## 34-087-20415 Pinkerman # 2 ERP CN

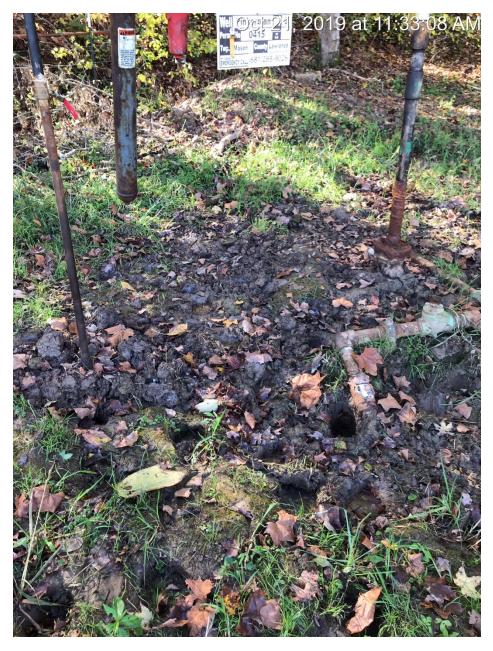
7-22-2019 Compliance Notice # 1536086906 follow up inspection. Francis Brothers service rig is on the well. They ran tubing sub joints with a tubing spear to retrieve the tubing and packer. Pulled the tubing and packer out of the well. Installed rebuilt Halliburton R-4 packer on used 2.375 inch tubing. Packer set at 522.95 feet. Tested annulus at 300 psi. at 5 minutes 290 psi, at 15 minutes 288 psi. The injection line is not connected to the injection tubing. Contaminated soil has not been removed from location.

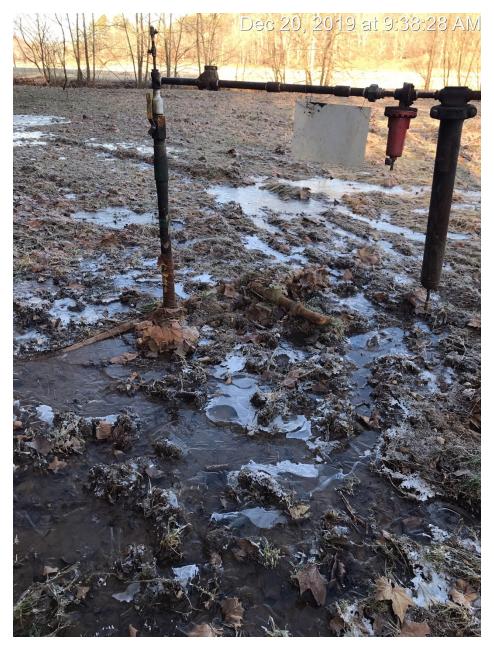
9-13-2019 Compliance Notice # 1536086906 follow up inspection. The contaminated soil has not been removed from the well site. The scald area around the well is 9 feet by 8 feet. The injection line has been connected to the injection tubing, all valves are open.
